Title-Sujet RCMP B Block Redevelopment		
Solicitation No. – No. de l'invitation 201405073	Amend. – Modif. No. : 5	Date March 24, 2014
Client Reference No. - No. de Référence du Client 201405073		
GETS Reference No. – No de Référence du SEAG 201405073		
Solicitation Closes – L'invitation prend fin at - à 2 :00 pm EST on - le March 31st, 2014		
F.O.B. - F.A.B. Destination		
Address Enquiries to: - Adresser toute questions à : Eric Glynn – Manager - Procurement		
Telephone No. - No de téléphone 613-843-5533	Fax: 613-825-0082	
Destination of Goods - Destinations des biens: See Herein		
Instructions : See Herein / Voir aux présentes		
Delivery Required – Livraison exigée: See Herein		
Name and Title of person authorized to sign on behalf of Vendor/Firm. Nom et titre de la personne autorisée à signer au nom du fournisseur/de l'entrepreneur

Amendment #5 of Solicitation 201405073 has been issued to provide Addendum #3 to the Specifications and Drawings.

1
 AR21 1:20 CATWALK GUARDRAIL DETAIL
 (@ JOINS OF RAILING SECTIONS)

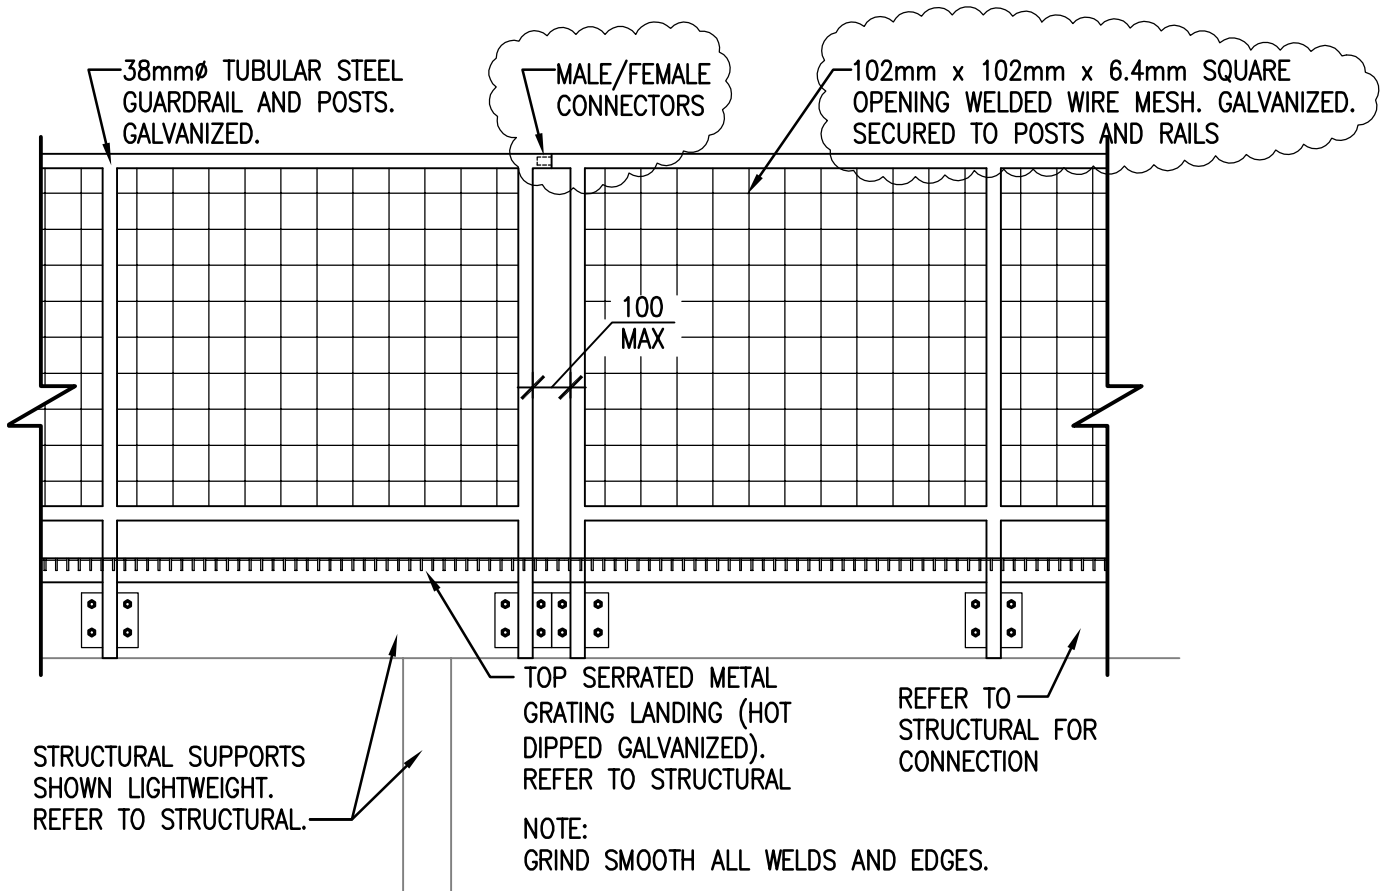
- .1 Reference Drawing 5, Catwalk Guardrail Detail; DELETE the middle horizontal rail of the guardrail, so as to leave only the top and bottom rails.
- .2 Reference Drawing 5, Catwalk Guardrail Detail; Divide the railing into section lengths as required for galvanizing after fabrication. Maintain module dimensioned on drawings for post spacing. Where lengths of railing sections join; provide two vertical posts, anchor plates and fasteners, and male/female connector at top rail. Refer also to detail 1/AR21 accompanying this addendum.
- .3 Reference Drawing 5, Catwalk Guardrail Detail; CLARIFICATION; Welded wire mesh to be welded to the horizontal railings and vertical posts.

NOTE:
 MODIFY MOUNTING OF GUARDRAIL WALL
 PLATES TO SUIT MAXIMUM SPACING
 BETWEEN THE TWO VERTICAL POSTS

Drawing:
E3.2R1

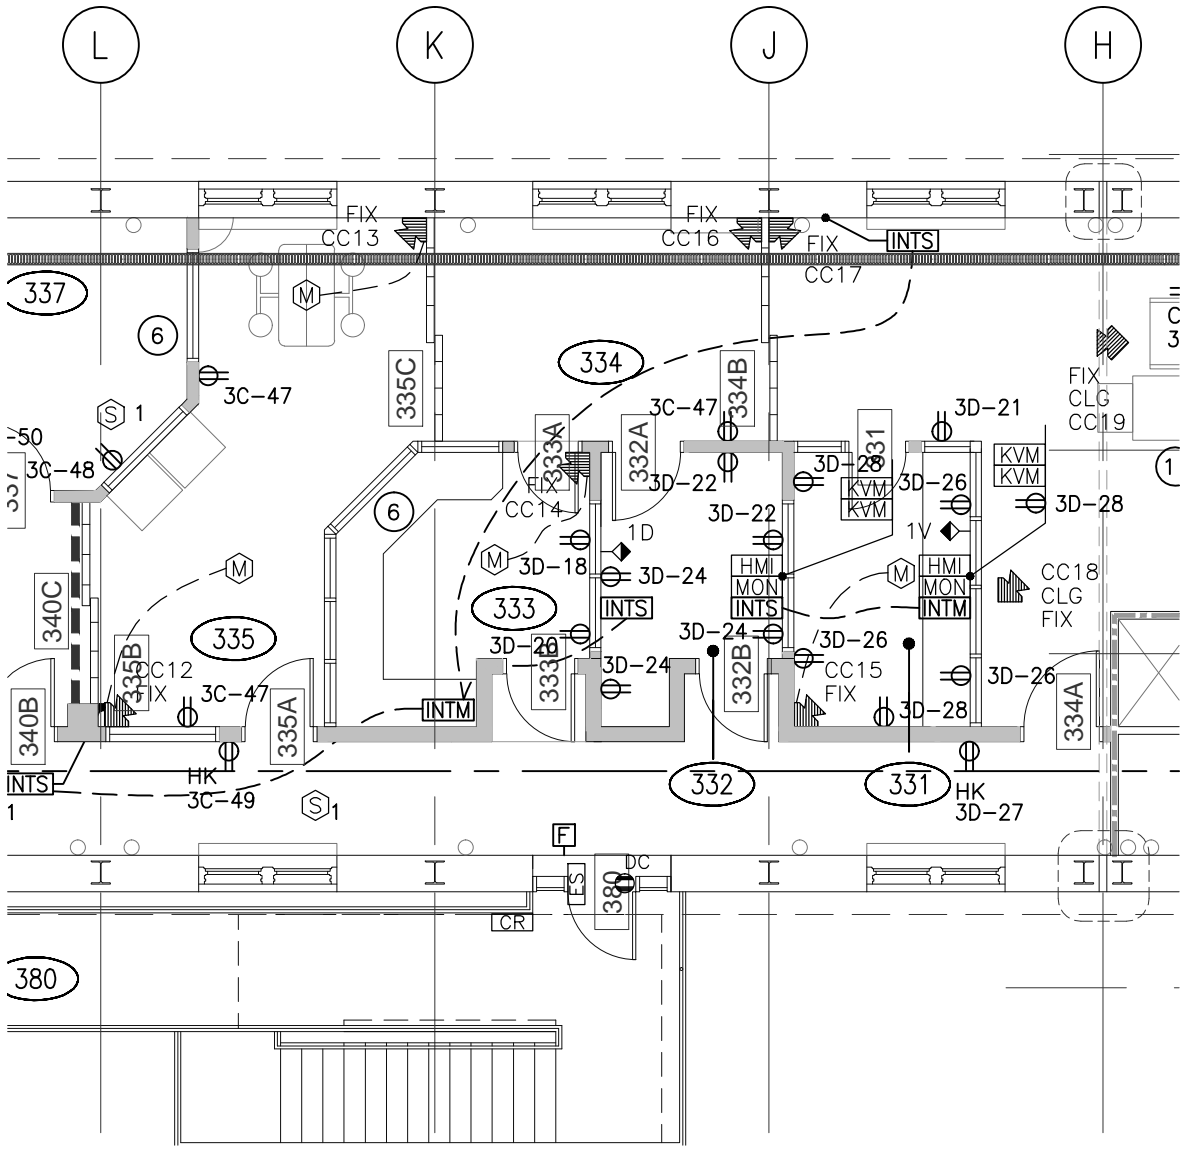
- .5 KVM extenders and duplex receptacle for rooms 331 & 332 are shown offset. Leaders did not show up correctly on PDF drawings, see sketch E3.2R1, accompanying this addendum, for correct locations.
